APPEAL RECOMMENDATION REPORT

City Planning Commission

Case No.: ZA-2018-7378-ZV-TDR-SPR-1A

PROJECT LOCATION: 1123-1161 South Main Street; 111 West 12th Street

MAX. HEIGHT OF
ADJACENT WINDOWS TO
PRIMARY ROOMS
157' - 6"

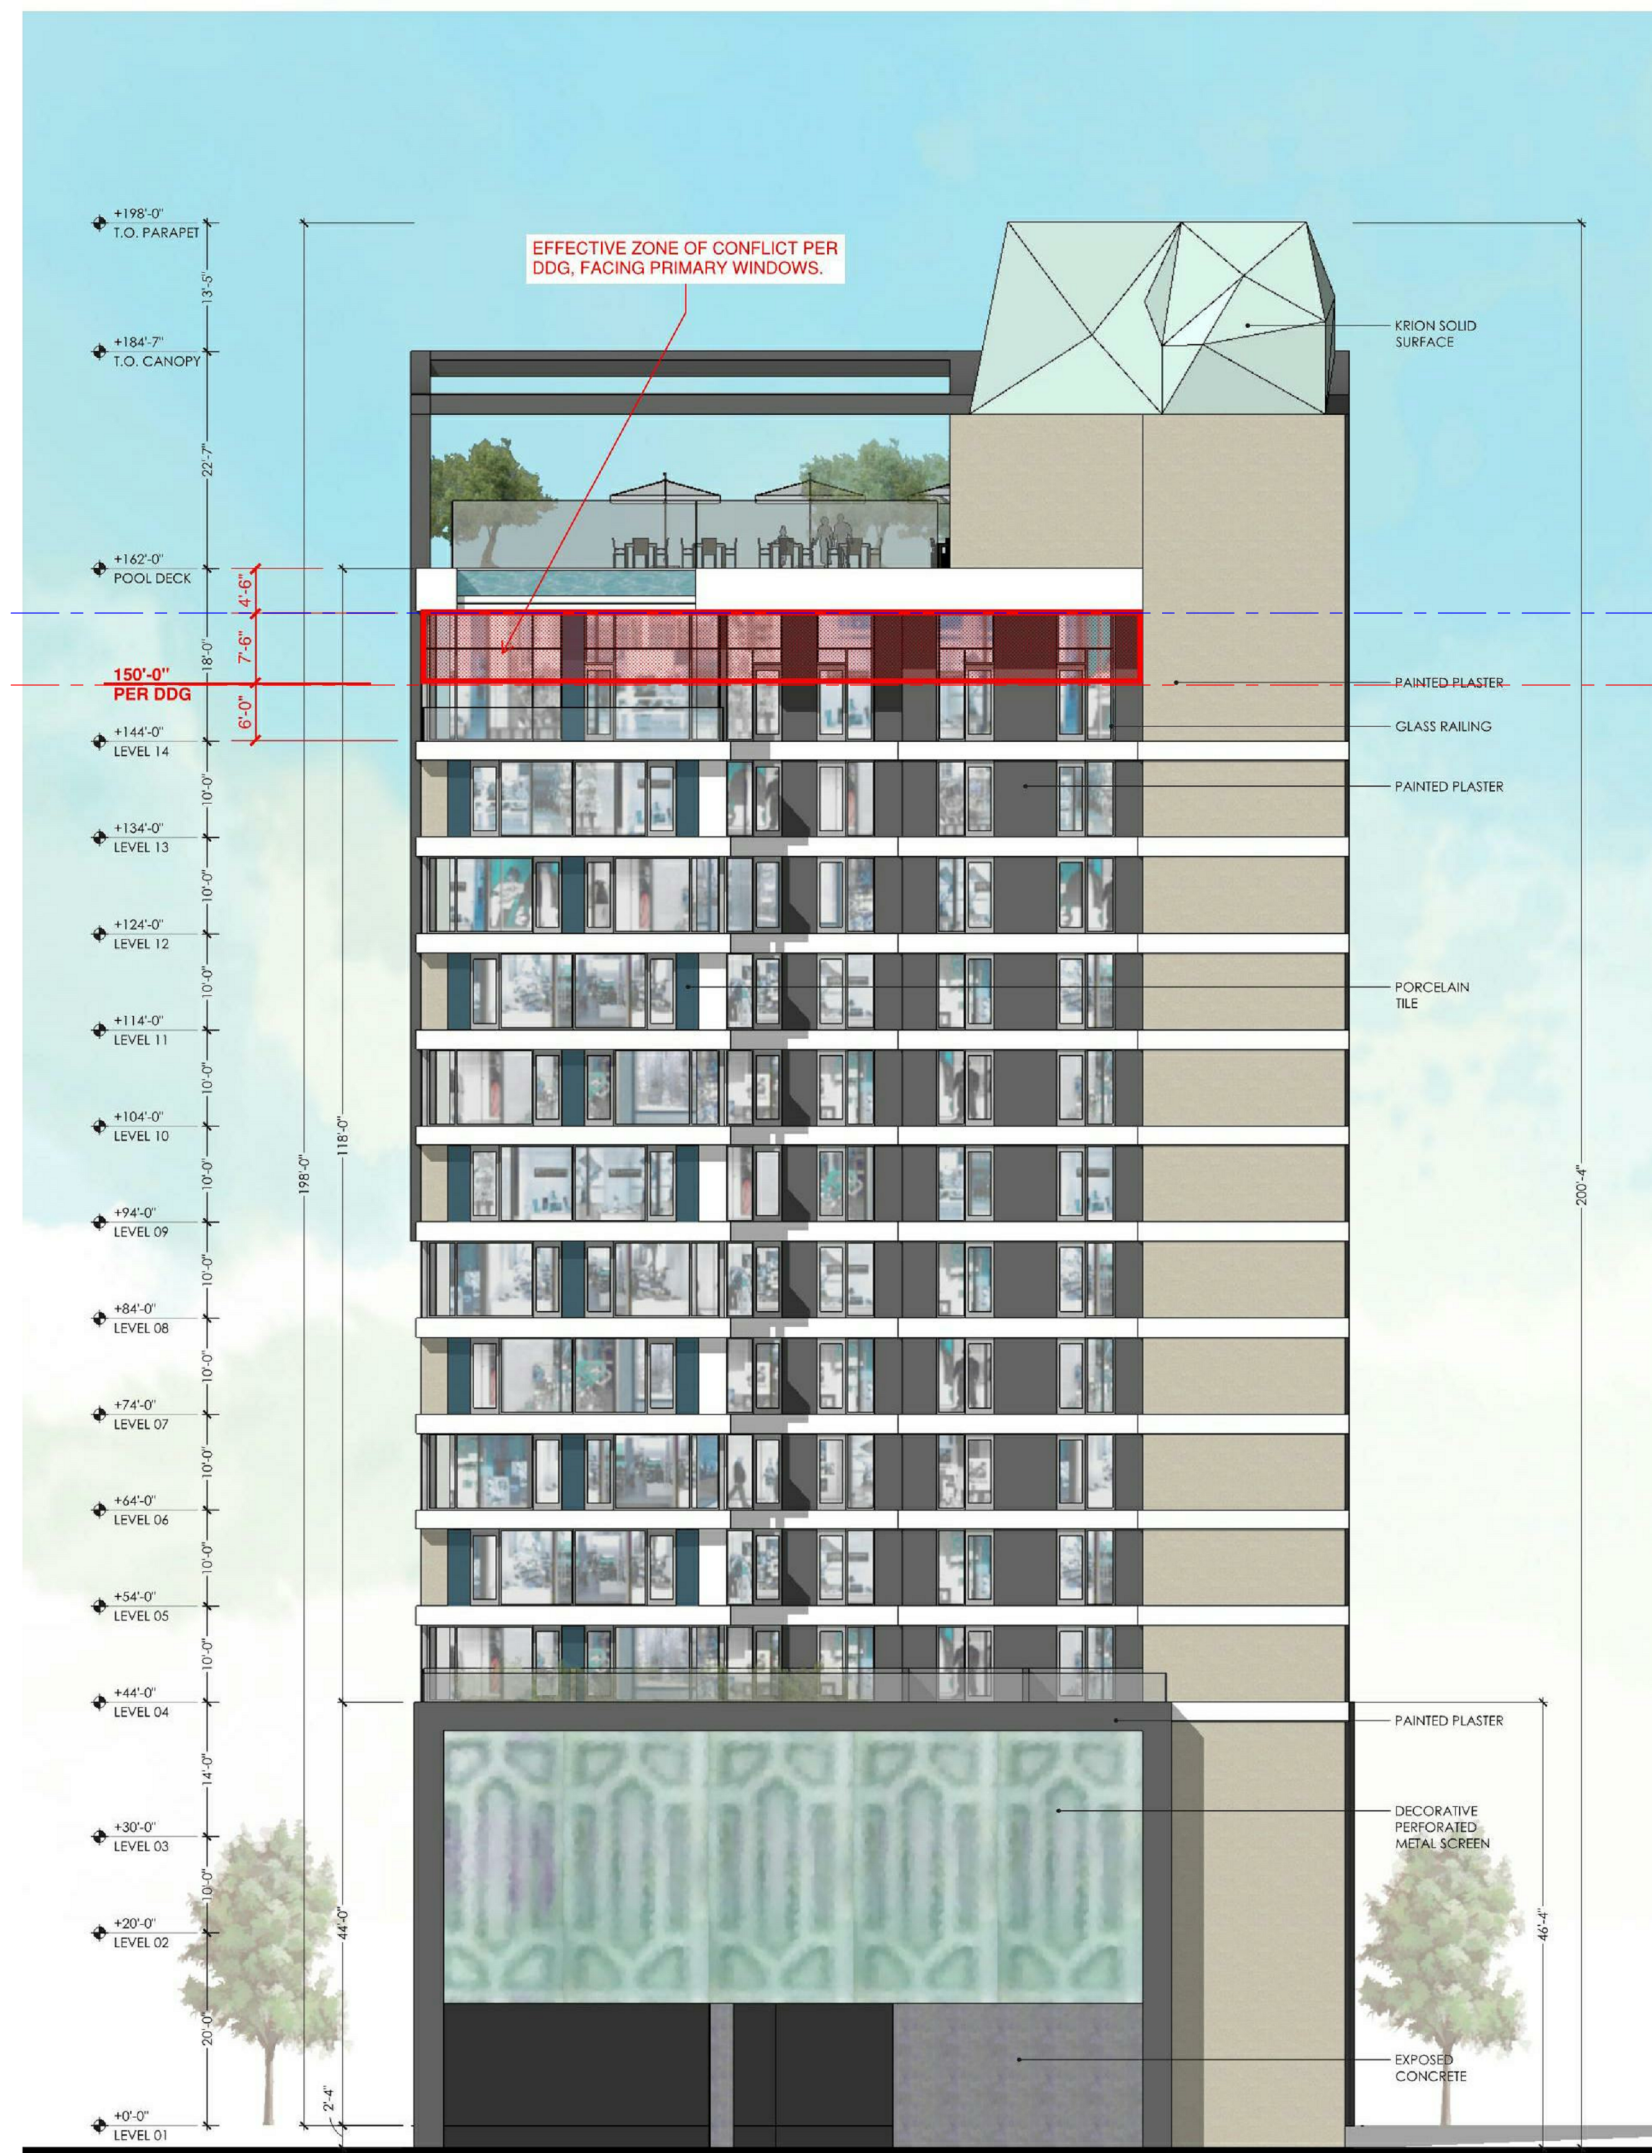
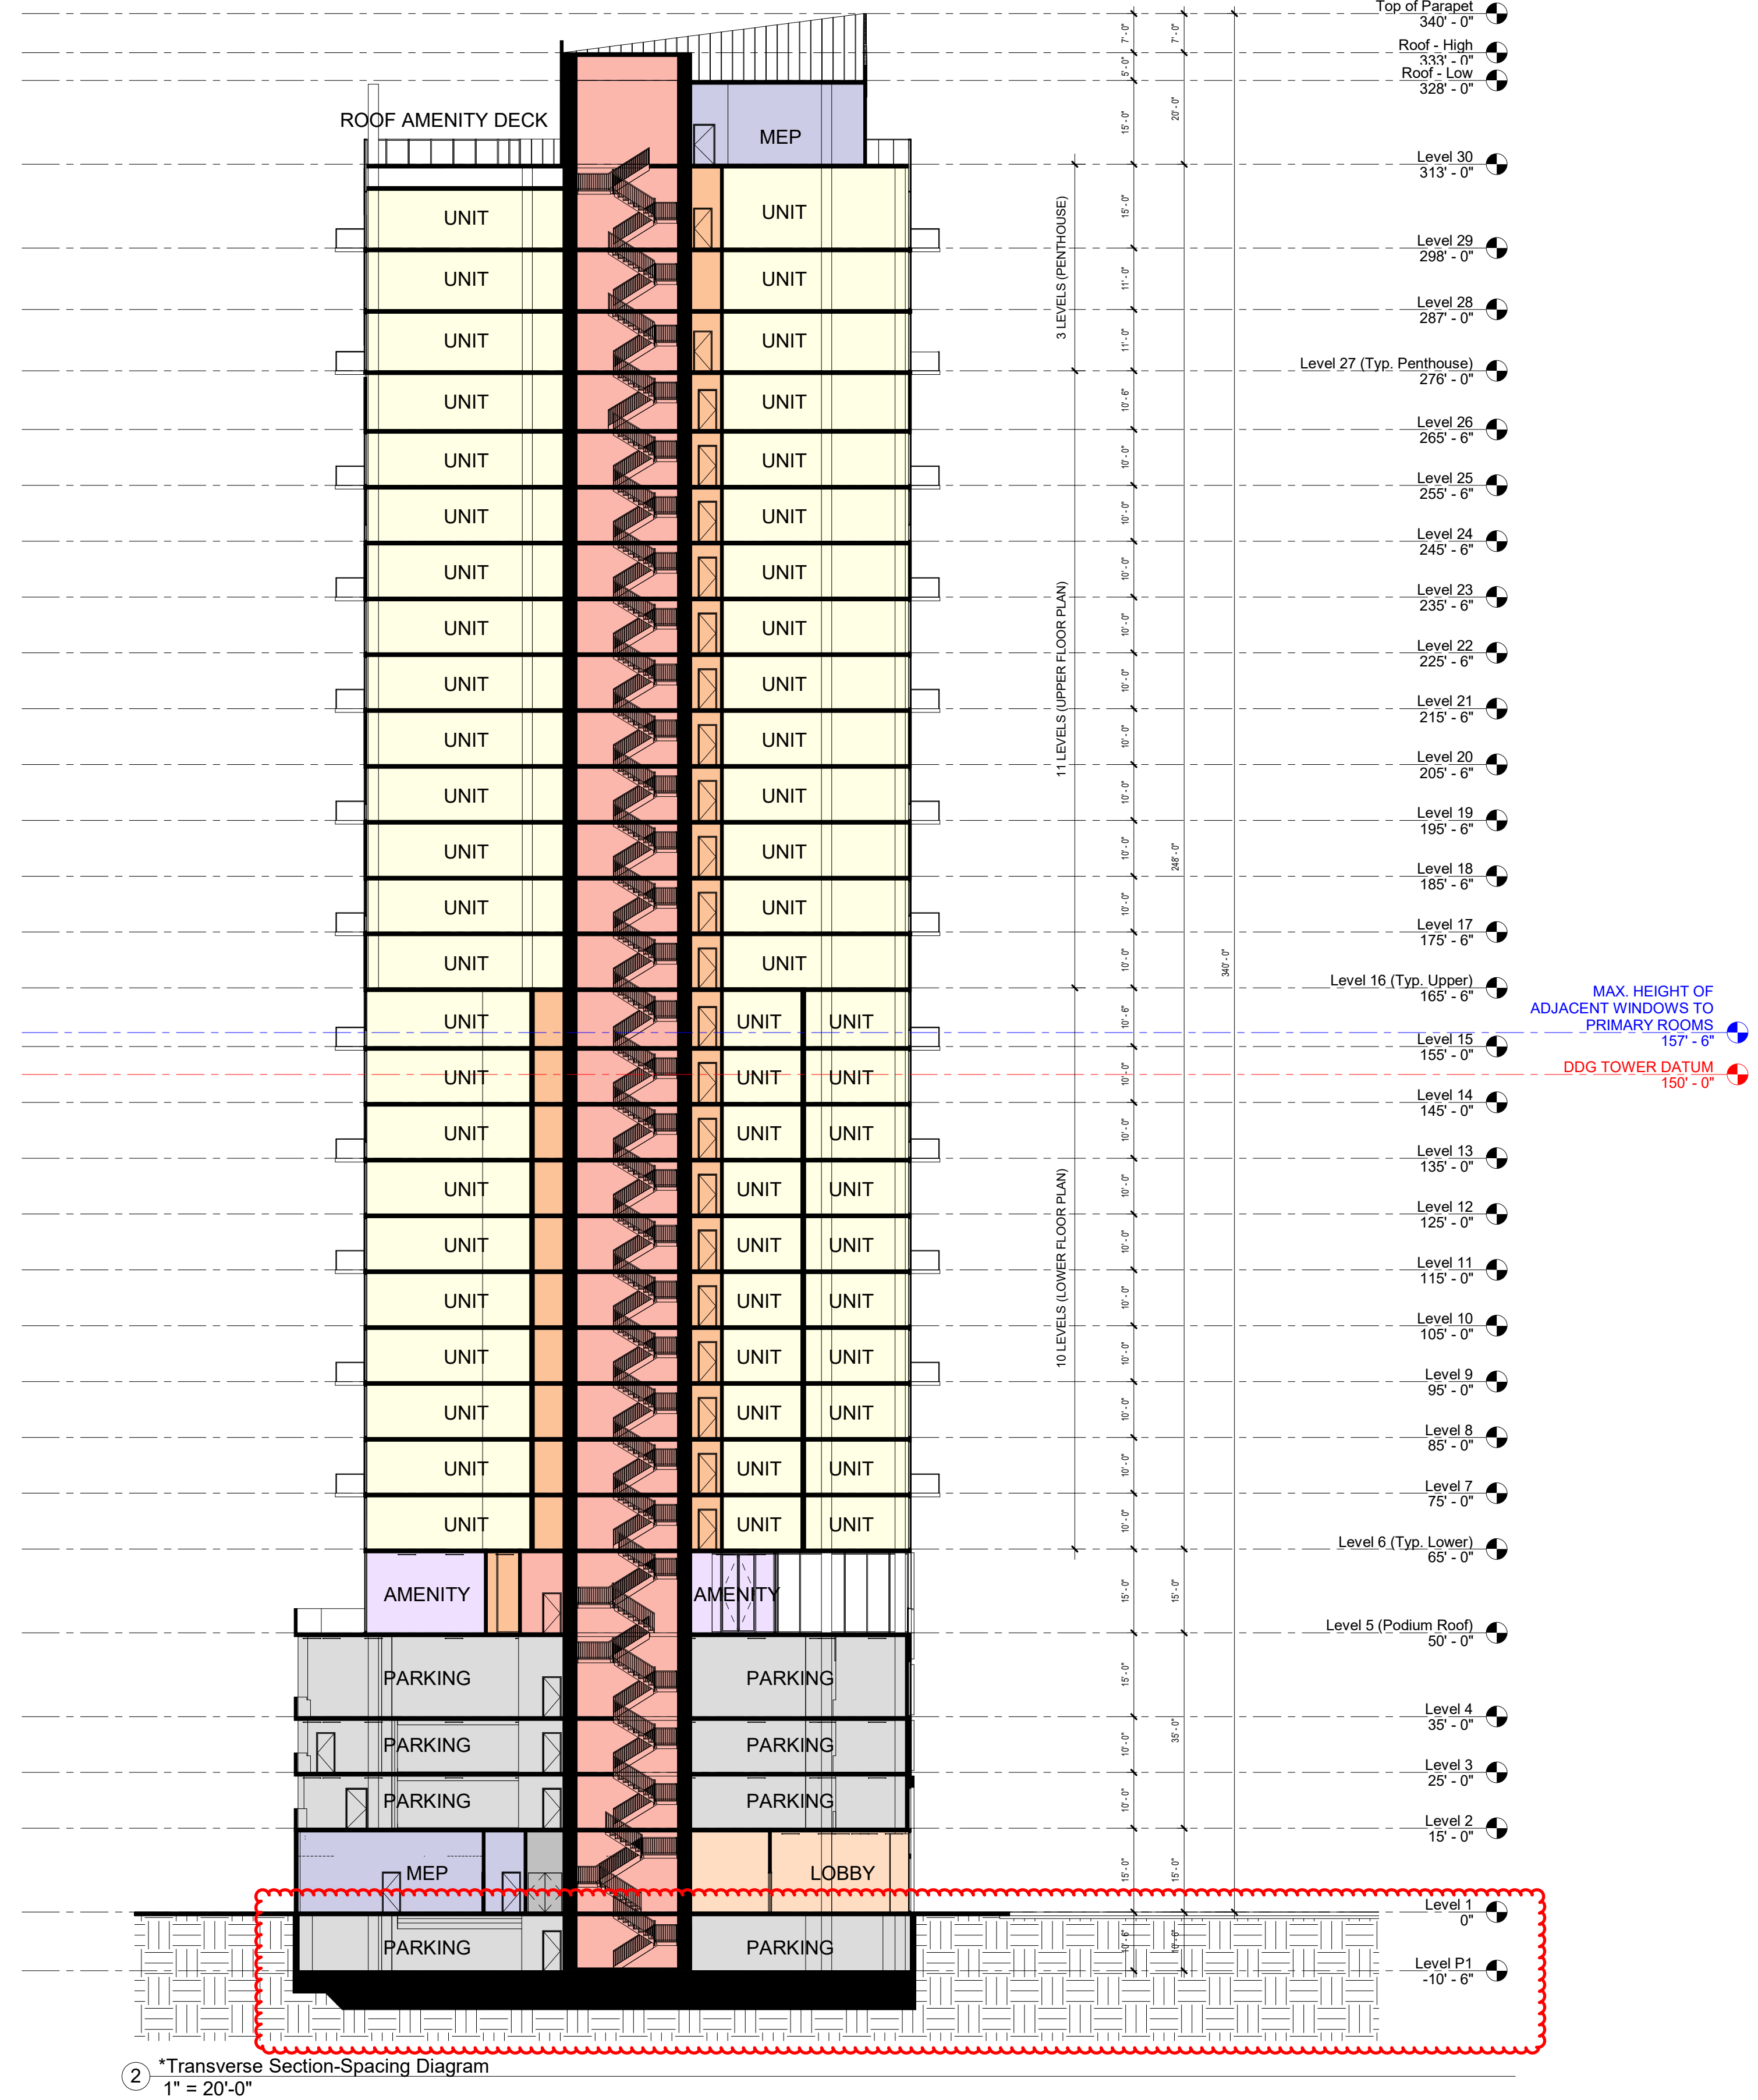
The Project's building (tower) arrangement, height, bulk, and setbacks are not compatible with the hotel abutting the Subject Property northerly. The tower would be better situated southerly, away from the hotel. Therefore, the Site Plan Review should not be granted for the Project's current design.

Regarding arrangement and setbacks, the project site is not subject to any setback limitations per the Greater Downtown Housing Incentive Area. Furthermore, the Downtown Design Guide requires the building street wall adjacent to retail use to be located at or within zero to five feet from the required sidewalk easements to activate streetfronts. As such, the proposed building is encouraged to be built close to, if not at, the property lines. Additionally, as previously mentioned, the Downtown Design Guide regulates space of towers, and as illustrated on Sheets 0.04 and 0.05 of the project plans (Exhibit A), the project tower is proposed to be offset or staggered from the tower proposed at the appellant's property at 1140 South Broadway. The proposed tower is separated from the 1140 South Broadway tower by approximately 71 feet and maintains sightline distances of greater than 40 feet between two buildings as required by the Downtown Design Guide.

- c. **Tower Spacing.** The proposed tower shall be located a minimum of 71 feet from the proposed hotel tower located at 1140 South Broadway, as shown on Sheet **s A0.04 and** A0.05 of Exhibit "A" **stamp-dated August 18, 2022.**
